MFN 09-298

Docket No. 52-010

Subject: **Partial Response to NRC RAI Letter No. 315 Related to ESBWR Design Certification Application – DCD Tier 2 Section 3.6 – Protection Against Dynamic Effects Associated with the Postulated Rupture of Piping; RAI Numbers 3.6-6 S03 parts a, c & d, 3.6-13 S02 and 3.6-16 S02**

DCD Markup for RAI Numbers:

Figure 3.6-3. Typical Terminal End Break at Containment Penetration

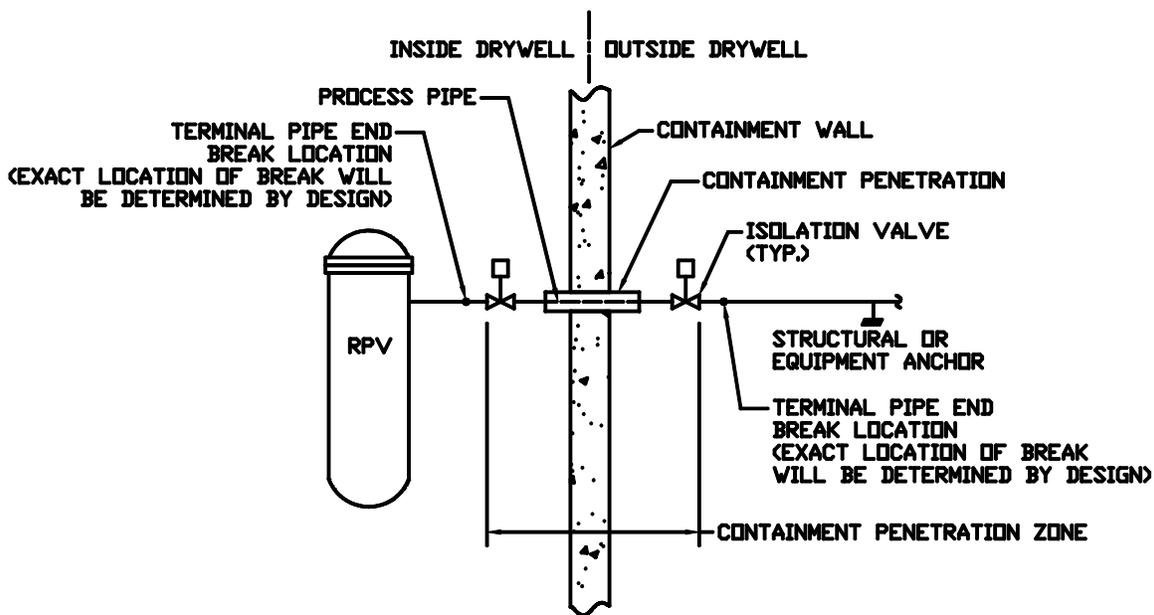
GEH provides two tables of terminal end pipe break locations. It appears that these lists may not be complete. For an example, it does not include terminal end pipe break locations at some pipe anchors that act as rigid constraints to pipe motion and thermal expansion. It should be noted that GEH has assumed the pipe element between the containment penetration as anchor point in its ESBWR main steam piping analysis that was previously provided to the staff during its main steam piping design review. However, the staff noted that containment penetration is not considered as anchor point in the tables included in this RAI response. GEH is requested to clarify this inconsistency and also explain how its criteria are consistent with the terminal end defined by Note 3 on Page 3-4-5 of BTP 3-4. In addition, GEH is requested to modify the DCD to clarify that all ESBWR piping design will be designed to minimize the stresses and fatigue usage factors such that piping intermediate pipe break locations are avoided as stated in this RAI response. The staff noted that criteria for postulating intermediate break are still included in the DCD Revision 5. Finally, pending final resolution of this RAI, GEH should include these pipe break location tables in a revised DCD.

Consistent with BTP 3-4, Note 3 on Page 3-4-5, GEH agrees with the NRC that terminal end breaks will need to be postulated at the containment penetration. A table (Table 3.6-7) will be added in DCD Tier 2, Chapter 3.6, to identify the terminal end breaks at the containment penetration for all high energy piping inside and outside the containment boundary. In addition, GEH will also add a figure in DCD Tier 2, Chapter 3.6, to clarify typical terminal end break locations inside and outside of the containment penetrations.

a) DCD Tier 2, Chapter 3.6, is being revised in Revision 6 to add Table 3.6-7 and Figure 3.6-3, as shown in the attached markup.

b) DCD Tier 2, Chapter 3.6, Section 3.6.2.1.1 is being revised in Revision 6 to add a statement with regard to the addition of the Figure 3.6-3, as shown in the attached markup.

d) DCD Section 3.6.2.1.1 is being revised in Revision 6 to add the statement, "*including the locations shown in Fig. 3.6-3*" to the terminal end bullet.

The terminal end pipe break locations for high energy lines inside and outside containment are provided in Tables 3.6-5 and 3.6-6. The high energy line breaks at the containment penetration outside of the containment penetration zone are provided in Table 3.6-7. Terminal end break locations in piping systems on both sides of the containment penetration are shown in Figure 3.6-3.
